CONGRUENT SOFTWARE, INC.**98 Colorado Avenue****Berkeley, CA 94707****(510) 527-3926****(510) 527-3856 FAX**

TO: IEEE P1394a Ballot Response Committee

DATE: March 30, 1999

RE: Subaction dual-phase retry protocol

Figure 9-x — Inbound subaction dual-phase retry state machine

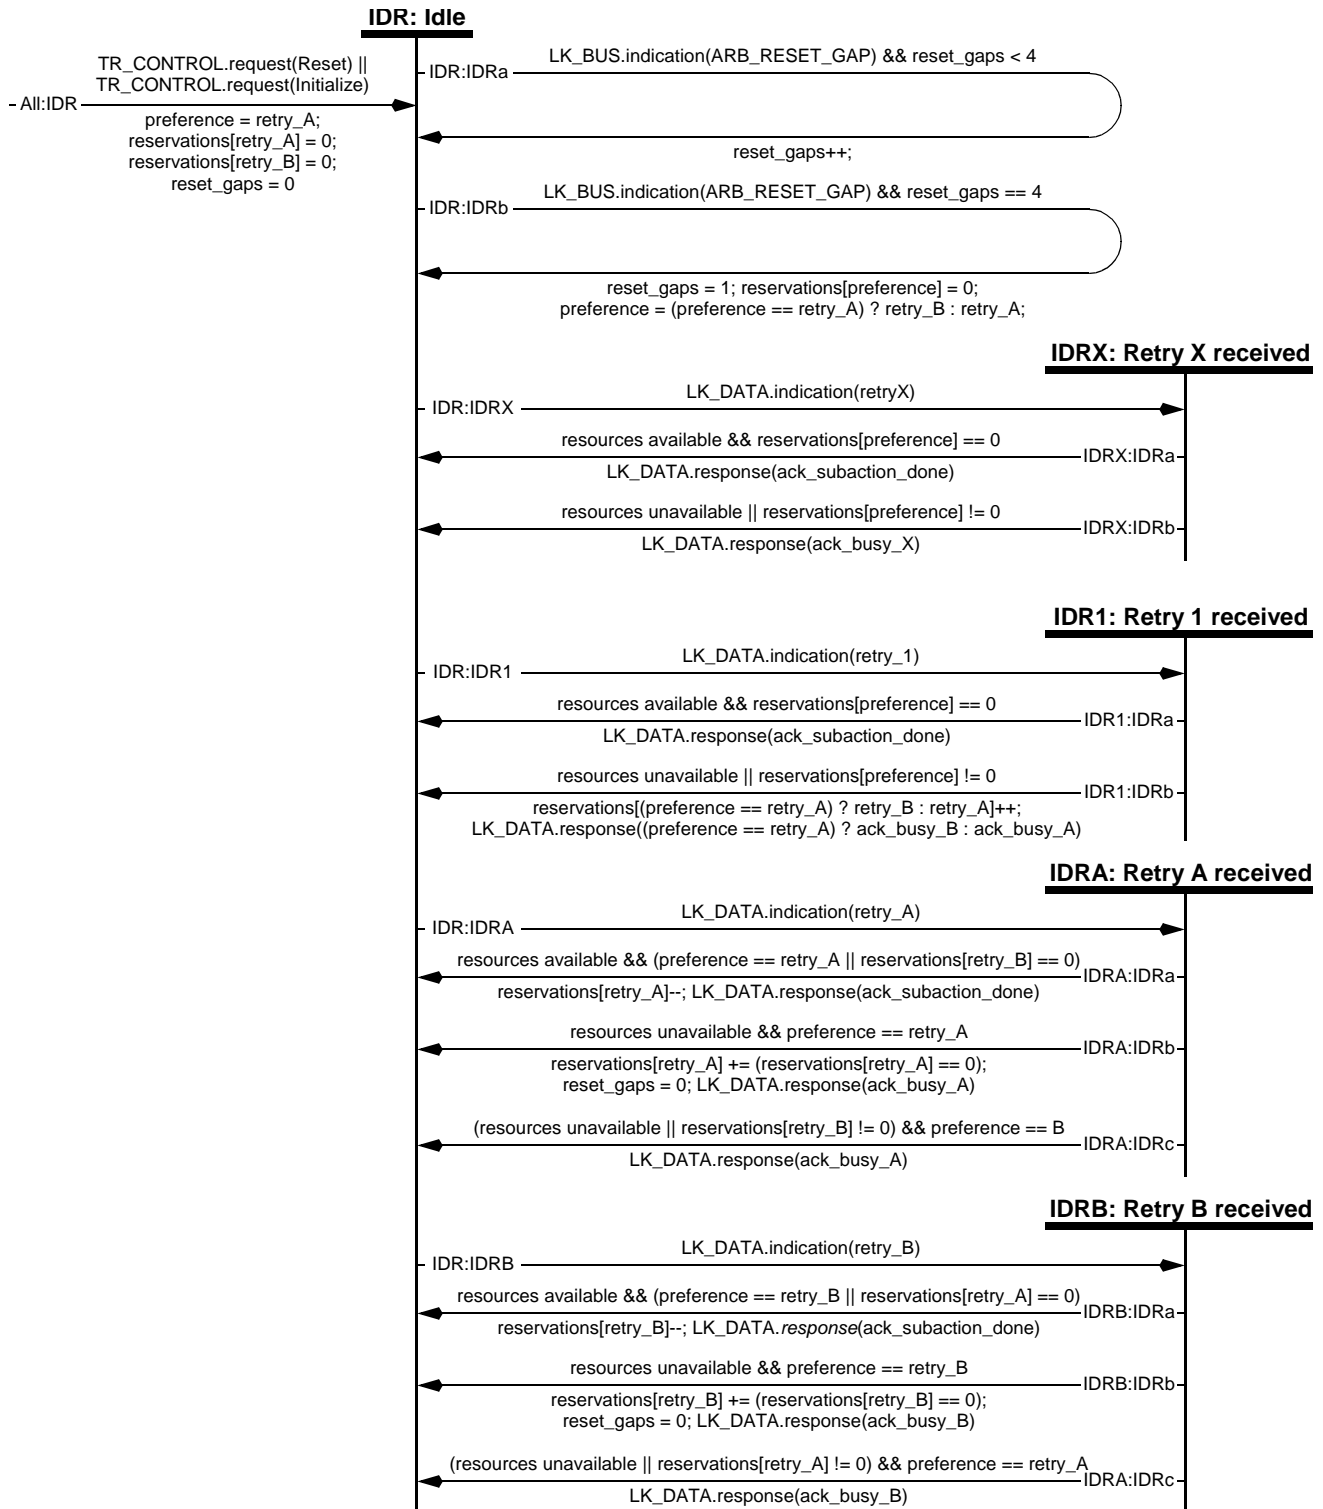
This clause replaces IEEE Std 1394-1995 clause 7.3.5.2, “Dual-phase retry protocol”, in its entirety. Revision of both the outbound and inbound state machines are necessary for the following reasons:

- Reservation time limit ambiguities. IEEE Std 1394-1995 specifies that retry reservations shall be held by the intended recipient for four arbitration fairness intervals before cancellation. Unfortunately, the point from which fairness intervals is measured is not clearly specified. Contemporary link implementations are known to have different (although reasonable) interpretations which are not interoperable.
- No resynchronization. The inbound dual-phase retry state machines in IEEE Std 1394-1995 do not resynchronize reservation histories (phase and count of outstanding reservations) when discrepancies exist between the outbound and inbound nodes.

In order to correct these problems and to add an enhancement (the ability to count the number of outstanding reservations for each phase), this supplement redefines dual-phase retry behavior for both outbound and inbound nodes. The maintenance of reservation counters permits an inbound node to immediately accept subactions that lack a resource reservation if there are no reservations held for pending subactions.

Transition All:IDR. The receipt of a *TR_CONTROL.request* with an action of either Reset or Initialize shall cause the inbound dual-phase retry state machine to set its reservation preference to *retry_A* and zero all retry counters.

Transition IDR:IDRa. The end of a fairness interval has been detected, indicated by an arbitration reset gap. If the accumulated count of reset gaps is less than four, the transaction layer shall increment the count..

Transition IDR:IDRb. The end of the last fairness interval available to the outbound node for the retry of a subaction for which the inbound node granted a reservation. The inbound node abandons all reservations for the currently preferred retry phase, switches its preference to the opposite retry phase and counts this fairness interval as the first of the four available to holders of reservations in the now preferred phase.

Transition IDRX:IDRa. Resources are available and there are no reservations outstanding for the currently preferred phase. The transaction layer shall accept the subaction and return an appropriate terminal acknowledge code.

Transition IDRX:IDRb. Resources are unavailable or there are reservations outstanding for the currently preferred phase. The transaction layer shall refuse the subaction without creating a reservation.

Transition IDR1:IDRb. Resources are unavailable or there are reservations outstanding for the currently preferred phase. The transaction layer shall refuse the subaction but create a reservation for the opposite phase. The acknowledge code returned to the outbound node, either *ack_busy_A* or *ack_busy_B*, shall indicate the phase of the newly created reservation.

Transition IDRA:IDRb. Resources are unavailable and *retry_A* is the currently preferred phase. If the reservation count for *retry_A* is nonzero, there are reservations outstanding for the currently preferred phase. The transaction layer shall refuse the subaction; the *ack_busy_A* acknowledge code returned indicates that the outbound node should continue retry attempts in the same phase. If the *retry_A* reservation count is zero, the outbound and inbound state machines are out of synchronization with respect to each other; the inbound dual-phase state machine corrects this by incrementing the reservation count.

Transition IDRA:IDRc. Although a retry code of *retry_A* was received from the outbound node, the currently preferred retry phase is for *retry_B*. If either resources are unavailable or there are *retry_B* reservations outstanding, the transaction layer shall refuse the subaction but continue to hold a *retry_A* reservation for the outbound node.
